# Product Change Notification

**Change Notification #:** 113440 - 00  
**Change Title:** Intel® Server System R1208BB4DC  
PCN 113440-00, Product Design  
Update the System Rear Panel  
**Date of Publication:** November 20, 2014

Figure One

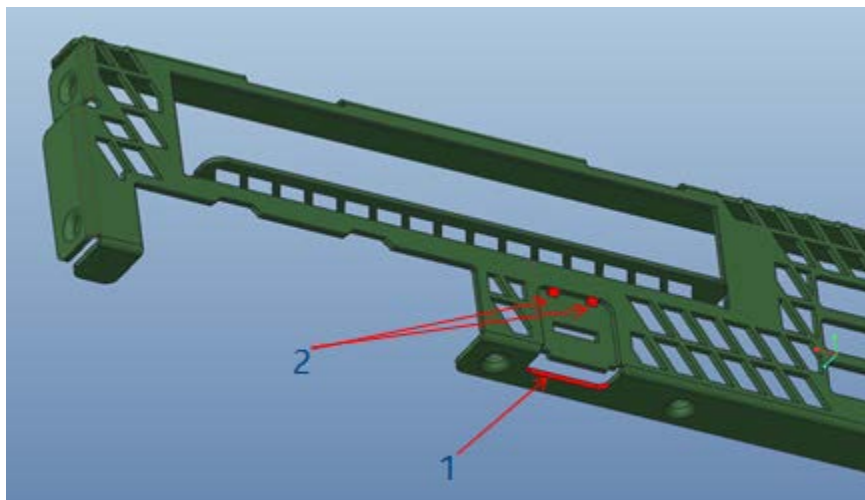
1. Add a connection at the bottom of the RMM4 (Remote Management Module 4) slot to improve structure strength. See item 1 in Figure One.
2. Update the one big center joint to two smaller joints so that the joints will not conflict with the LAN cable connector latch. See item 2 in Figure One.

Figure Three

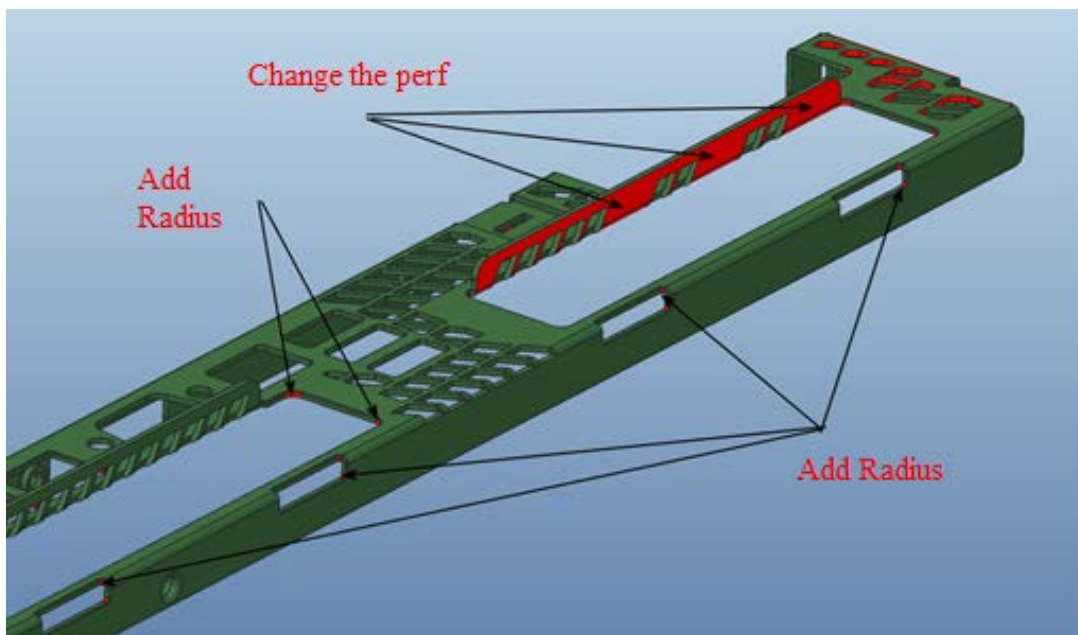
4. Update the perf and add radius to improve structure strength. See Figure Three and Four.

Figure Five

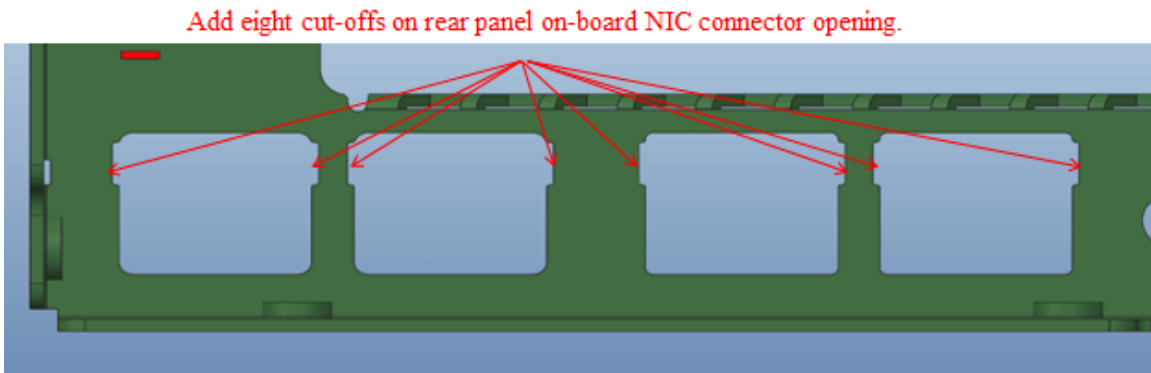
5. Add eight cut-offs around the on-board NIC (Network Interface Controller) openings to improve the LED visibility. See Figure Five.
